ULNRC-03447

**CALLAWAY PLANT**

**CONTROL ROD INSERTION PROBLEMS**

FIGURE 1

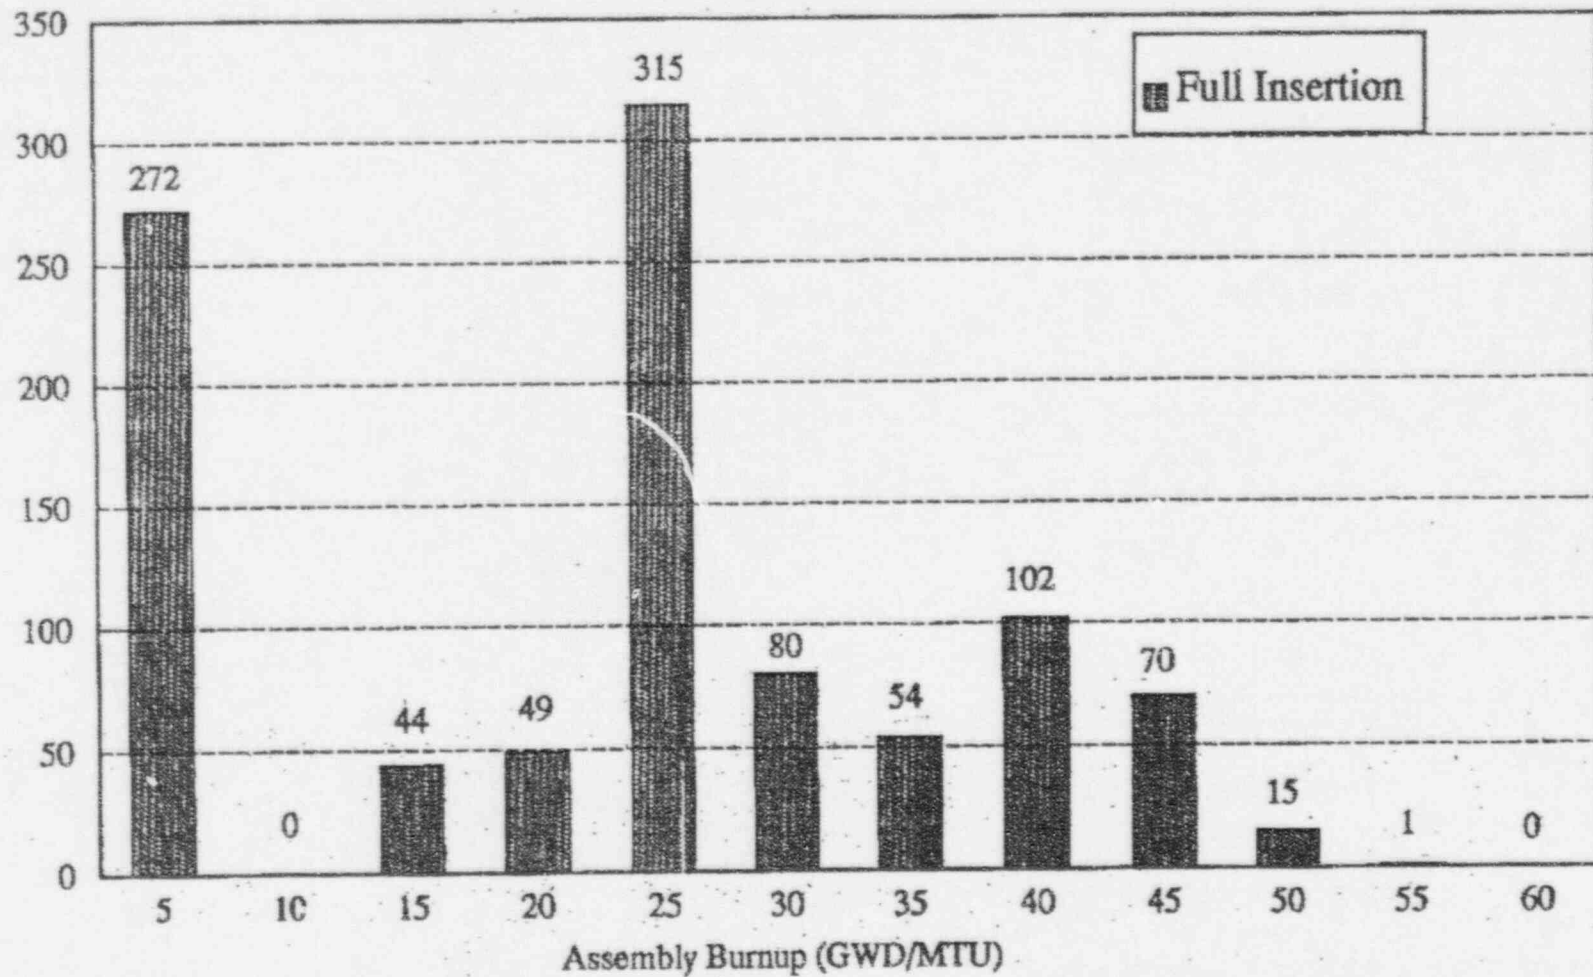
Westinghouse data provided in Figure 1 show that during recent testing at 10 plants, over 1,000 RCCA's in VANTAGE 5/IFM fuel assemblies inserted fully and promptly with no exceptions. Note that 322 RCCA's were tested in fuel assemblies having burnups of 27,500 MWD/MTU or higher.

FIGURE 2

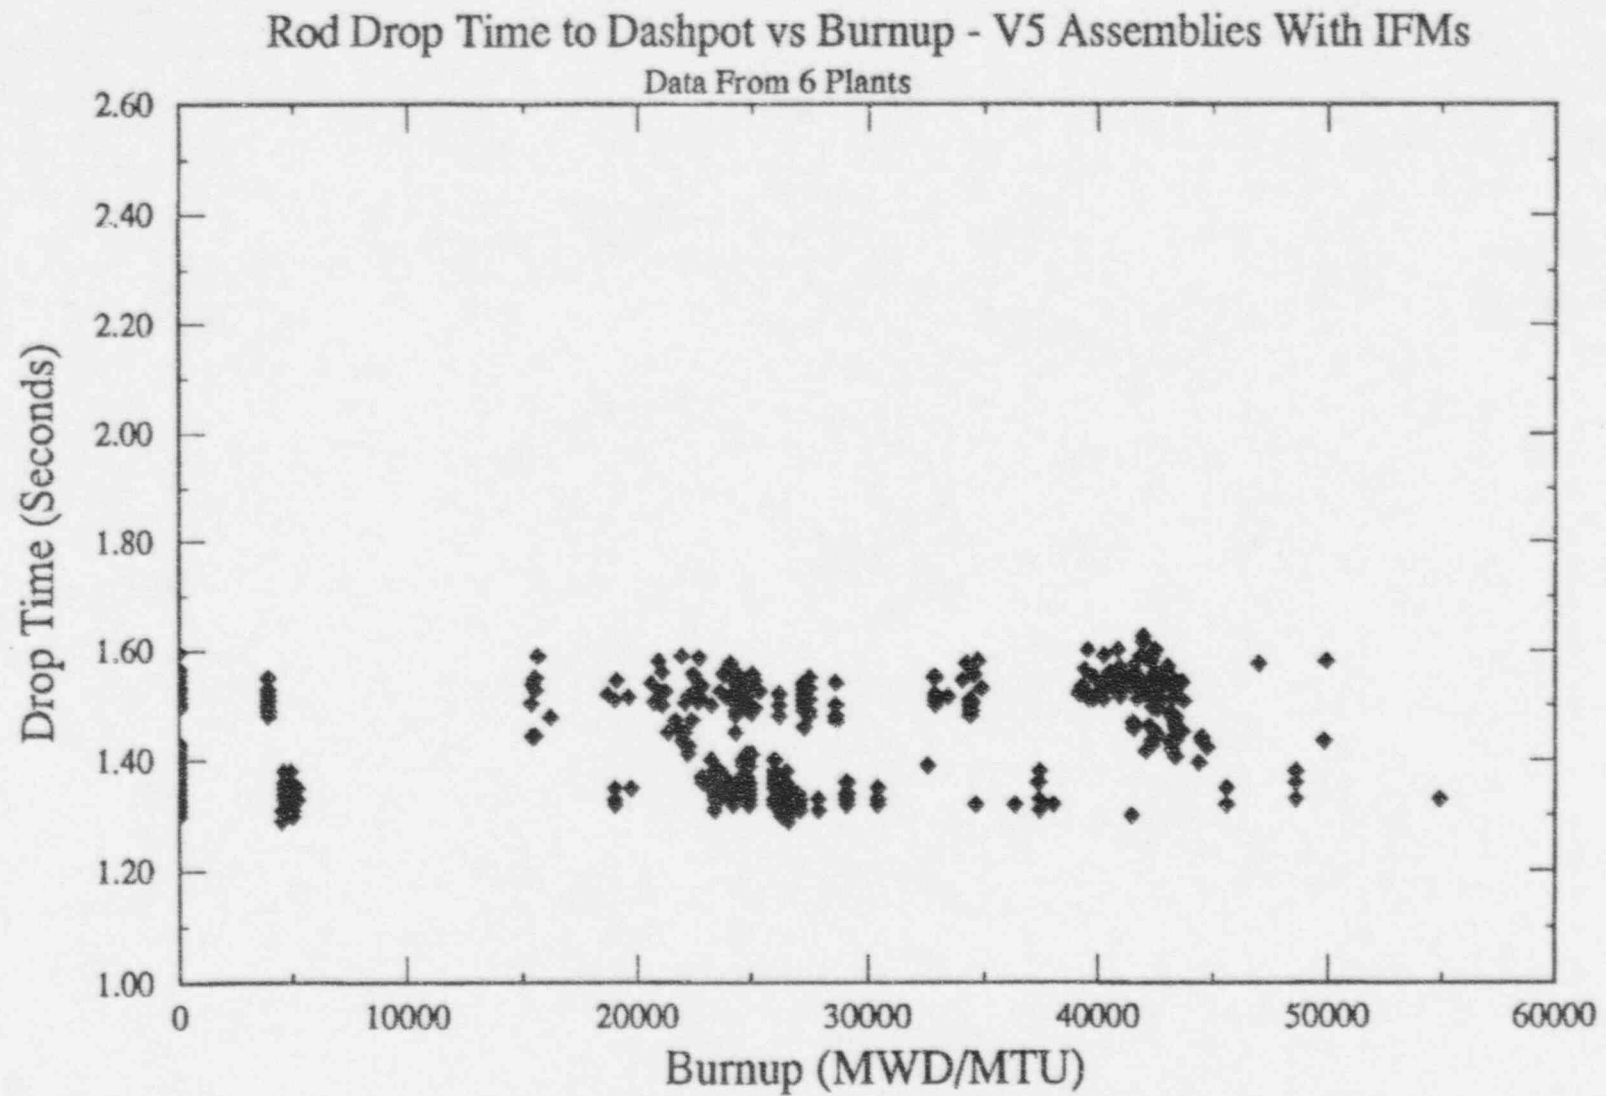
Westinghouse data presented in Figure 2 shows rod drop time to dashpot vs. burnup for V5/IFM assemblies for six of the ten plants represented in Figure 1. Again, all of the plants for which data is available registered RCCA drop times to dashpot entry well below tech spec requirements. Five of these six plants also reviewed data for recoil. The 514 RCCA's involved inserted into V5/IFM assemblies having burnups ranging from 0 to 55,000 MWD/MTU, and 110 of these assemblies had burnups of 30,000 or higher. Recoil was present on all RCCA's tested. These five plants included two of the four cited earlier which have core outlet temperatures similar to Callaway.
